North Central Texas  
Council of Governments

## Recommended Amendments to the 2021 International Building Code

North Central Texas Council of Governments Region

Figure 307.4

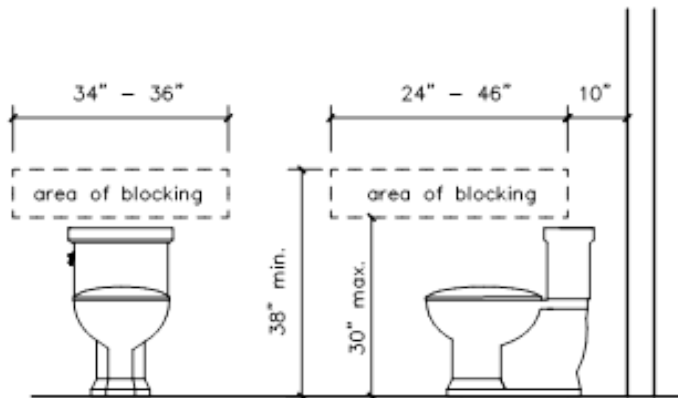
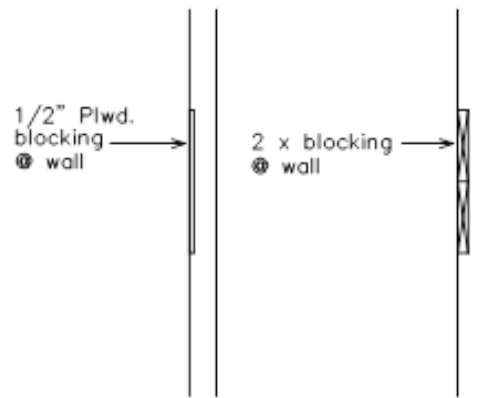
**\*\*\*R307.3 Blocking.** Required at one toilet at grade level. Blocking per Sec. R307.4 and Figure 307.4, shall be installed at rear wall and one wall adjacent to toilet at the lowest living level where a toilet is provided.

**\*\*\*R307.4 Blocking.** Blocking may be 1/2" plywood or equivalent or 2 x solid wood blocking flush with wall.

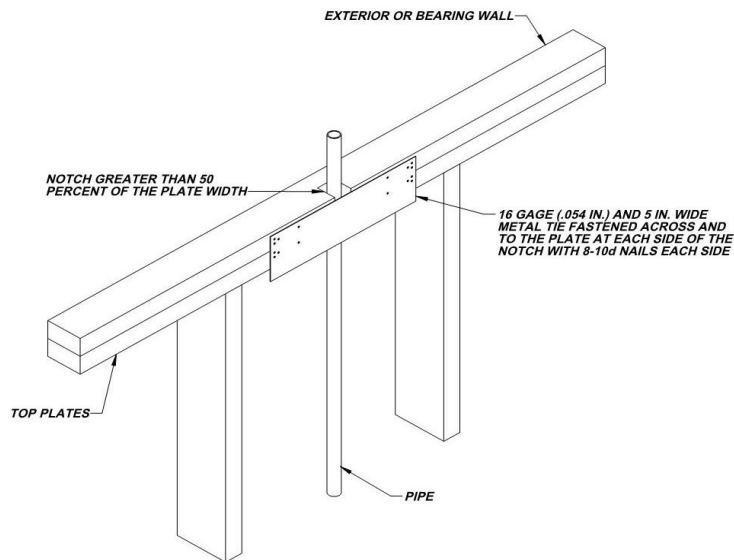
**\*\*Section R602.6.1; amend the following:**

**R602.6.1 Drilling and notching of top plate.** When piping or ductwork is placed in or partly in an exterior wall or interior load-bearing wall, necessitating cutting, drilling or notching of the top plate by more than 50 percent of its width, a galvanized metal tie not less than 0.054 inch thick (1.37 mm) (16 Ga) and ~~4 1/2 inches (38 mm)~~ 5 inches (127 mm) wide shall be fastened across and to the plate at each side of the opening with not less than eight 10d (0.148 inch diameter) having a minimum length of 1 1/2 inches (38 mm) at each side or equivalent. Fasteners will be offset to prevent splitting of the top plate material. The metal tie must extend a minimum of 6 inches past the opening. See figure R602.6.1. *{remainder unchanged}*

**\*\*Figure R602.6.1; delete the figure and insert the following figure:**

ADD: Figure: 25 TAC §265.186 (e) (6)

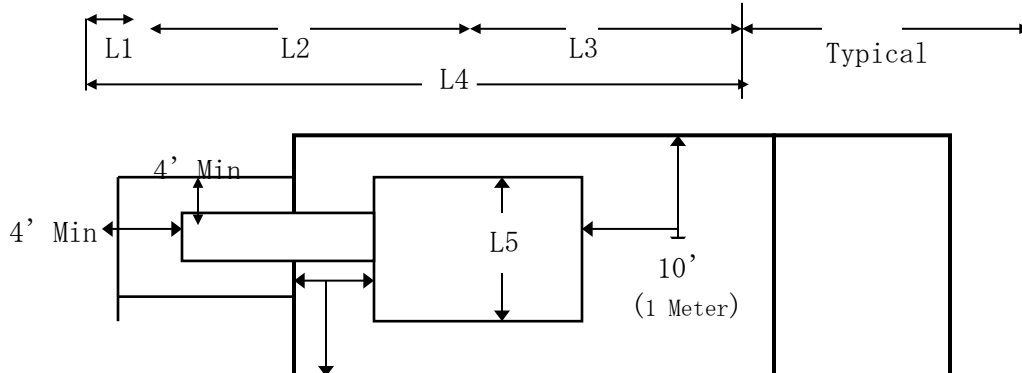
**\*\* Section 402.12; Change to read as follows:**

**402.12 Water envelopes.** The minimum diving water envelopes shall be in accordance with ~~Table 402.12~~ **Texas department of State Health services, Administrative Code Title 25, Chapter 265, Section 186 (e) and Figure: 25 TAC 256.186 (e) (6).** (Delete Table 402.12 and Figure 402.12)

Maximum Diving Board Height Over Water	¾ Meter	1 Meter	3 Meters
Max. Diving Board Length	12 ft.	16 ft.	16 ft.
Minimum Diving Board Overhang	2 ft. 6 in.	5 ft.	5 ft.
D1 Minimum	8 ft. 6 in.	11 ft. 2 in.	12 ft. 2 in.
D2 Minimum	9 ft.	10 ft. 10 in.	11 ft. 10 in.
D3 Minimum	4 ft.	6 ft.	6 ft.
L1 Minimum	4 ft.	5 ft.	5 ft.
L2 Minimum	12 ft.	16 ft. 5 in.	19 ft. 9 in.
L3 Minimum	14 ft. 10 in.	13 ft. 2 in.	13 ft. 11 in.
L4 Minimum	30 ft. 10 in.	34 ft. 7 in.	38 ft. 8 in.
L5 Minimum	8 ft.	10 ft.	13 ft.
H Minimum	16 ft.	16 ft.	16 ft.
From Plummet to Pool Wall at Side	9 ft.	10 ft.	11 ft. 6 in.
From Plummet to Adjacent Plummet	10 ft.	10 ft.	10 ft.
